Appendix 5: Further Information received from the Applicant

RE: MPDC – Te Whare Whakapakari – Resource Consent

Matamata Indoor Sports Stadium – Transportation Assessment

Figure 1: Recorded Parking Occupancy

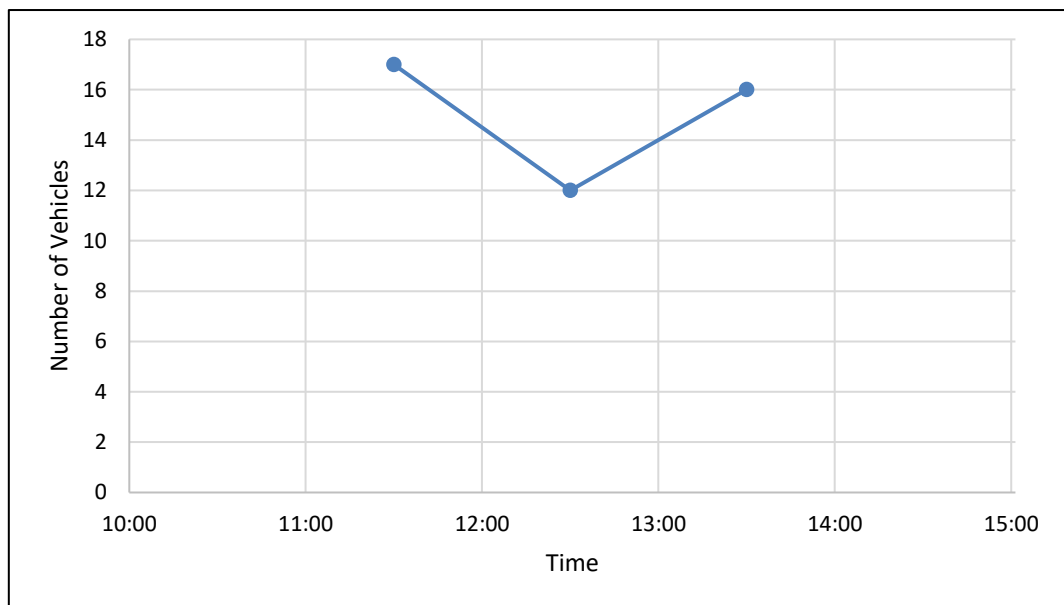
Council has requested commentary in relation to the average parking occupancy on Station Road, and in particular, the number of the available 126 spaces that will be available during large events.

Figure 1 shows a maximum parking occupancy of 17 vehicles at 11.30am, with all vehicles parked on Station Road. The majority were parked either at the eastern end near the neighbourhood shops, or at the western end immediately east of Smith Street. There were few vehicles parked adjacent to the site.

Table 1 shows that, on the day of the survey, approximately 109 parking spaces were available along Station Road. It is therefore assessed that ample on-street parking is available on Station Road to accommodate the expected overflow parking demand, without the need to use the available parking on Kowhai Street, College Street, or Hampton Terrace.

Figure 2: Potential Additional On-Site Parking

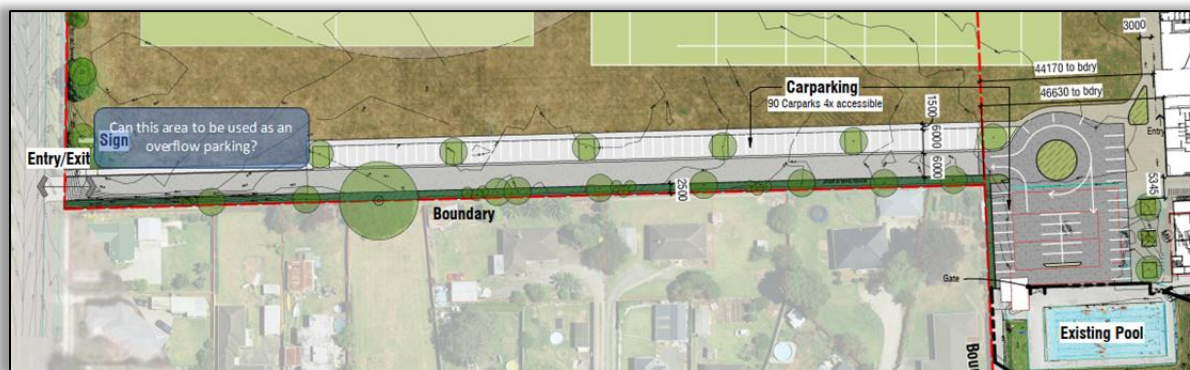
Council has suggested increasing the on-site parking to be provided, as shown of the figure below.

Section 1 of this report notes that, for indoor recreation buildings, the District Plan requires 93 on-site car parking spaces to be provided, while the expected peak parking demand was assessed at 80 spaces. A total of 94 on-site car parking spaces are proposed, which exceeds both the District Plan parking requirement and the expected typical peak parking demand. The transportation assessment report assessed that an appropriate level of parking is proposed to accommodate the expected typical day to day use of the stadium, without the need for overflow parking onto the adjacent roads. It is therefore assessed that any additional on-site parking provided within the area identified above will only be used for the larger events, of which, up to six are proposed each year.

It is expected that this area could provide up to approximately 20 spaces, which would reduce the expected overflow parking demand for the large events from 88 spaces to 68 spaces. It is therefore expected that there will still be overflow parking associated with these larger events and that a TPMP will still be required. Given that this area would be used up to six times per year, is insufficient to accommodate the full expected overflow parking demand, and that a travel management plan will still be required for the remaining overflow parking, it is assessed that there is little benefit in providing the additional parking. It is however noted that the TPMP may choose to use this area for additional parking if considered beneficial.

DRAWING No	02
SCALE	1:250 @A3

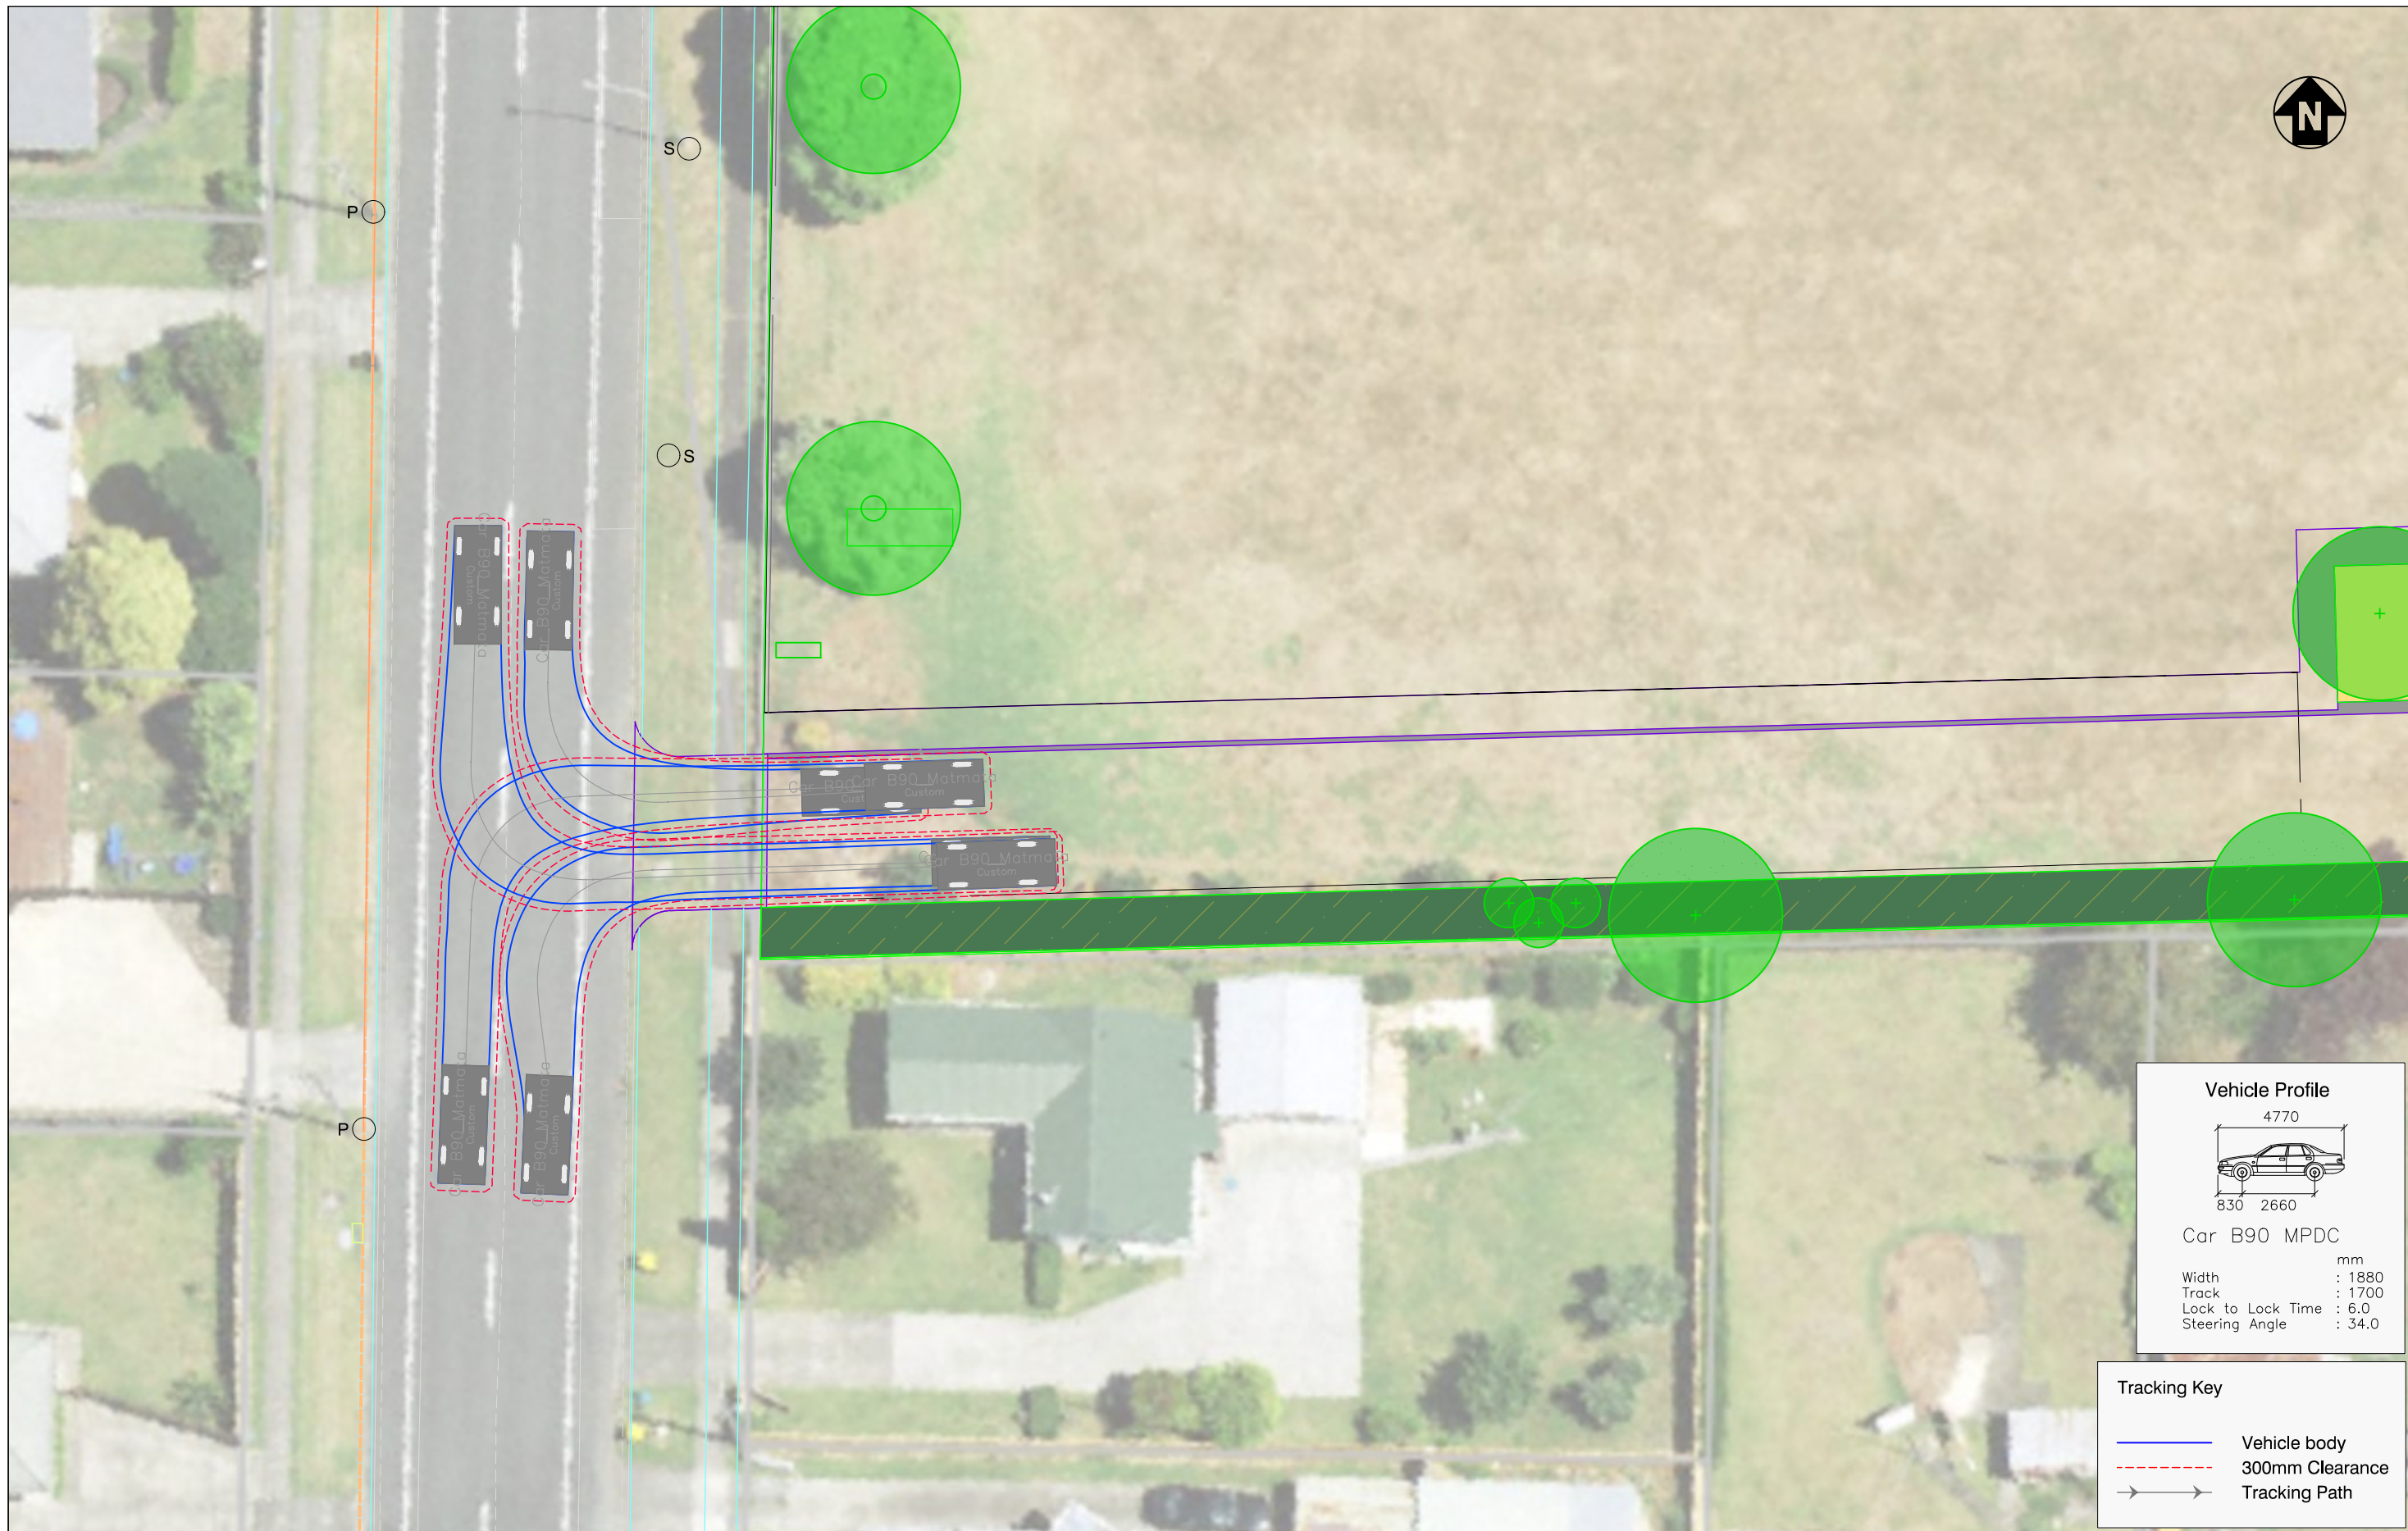
Council has requested commentary on the proposed access layout and whether the proposed access/egress onto Station Road will adequately provide for the ADT on a day to day basis. Council has also requested whether any mitigating measures should be adopted for the access/egress point during large events.

The Development Manual requires two-way vehicle crossings for business activities to have a cut-down length of 6.0 m. The proposed vehicle crossing will be 6.0 m wide, which is in accordance with this requirement. The tracking path of light vehicles using the access is

shown on the attached Drawing 02. This shows that the vehicle crossing will accommodate the regular, day to day two-way movement of light vehicles.

Figure 1: Recorded Parking Occupancy

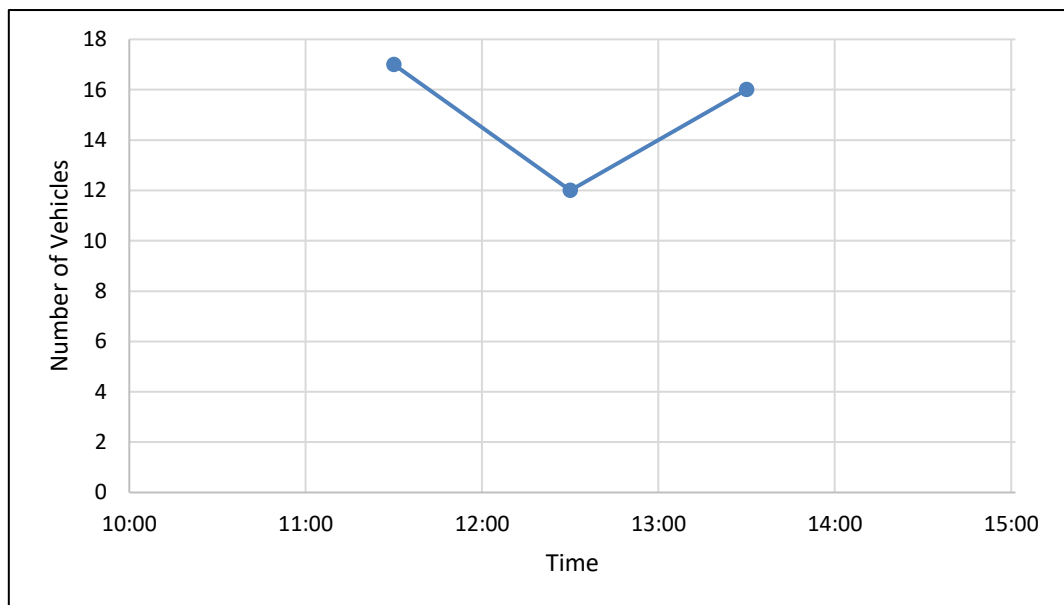
Council has requested commentary in relation to the average parking occupancy on Station Road, and in particular, the number of the available 126 spaces that will be available during large events.

Figure 1 shows a maximum parking occupancy of 17 vehicles at 11.30am, with all vehicles parked on Station Road. The majority were parked either at the eastern end near the neighbourhood shops, or at the western end immediately east of Smith Street. There were few vehicles parked adjacent to the site.

Figure 2: Potential Additional On-Site Parking

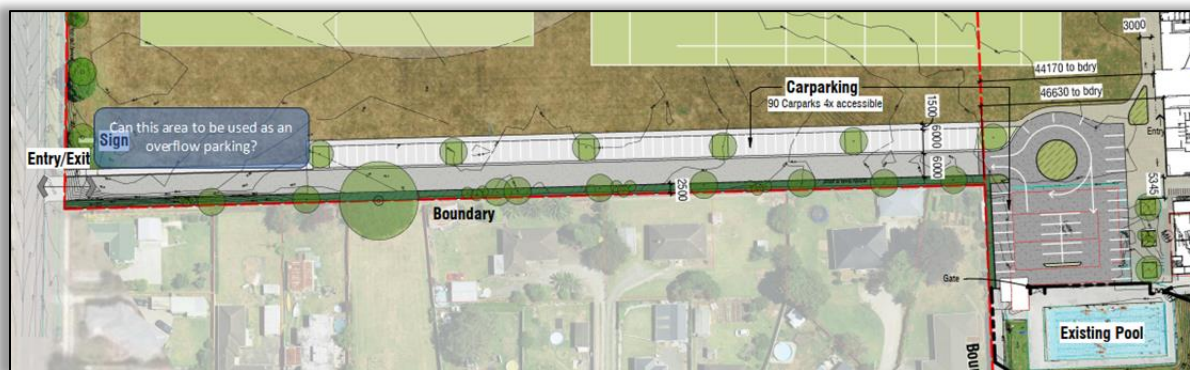
Council has suggested increasing the on-site parking to be provided, as shown of the figure below.

Section 1 of this report notes that, for indoor recreation buildings, the District Plan requires 93 on-site car parking spaces to be provided, while the expected peak parking demand was assessed at 80 spaces. A total of 94 on-site car parking spaces are proposed, which exceeds both the District Plan parking requirement and the expected typical peak parking demand. The transportation assessment report assessed that an appropriate level of parking is proposed to accommodate the expected typical day to day use of the stadium, without the need for overflow parking onto the adjacent roads. It is therefore assessed that any additional on-site parking provided within the area identified above will only be used for the larger events, of which, up to six are proposed each year.

It is expected that this area could provide up to approximately 20 spaces, which would reduce the expected overflow parking demand for the large events from 88 spaces to 68 spaces. It is therefore expected that there will still be overflow parking associated with these larger events and that a TPMP will still be required. Given that this area would be used up to six times per year, is insufficient to accommodate the full expected overflow parking demand, and that a travel management plan will still be required for the remaining overflow parking, it is assessed that there is little benefit in providing the additional parking. It is however noted that the TPMP may choose to use this area for additional parking if considered beneficial.
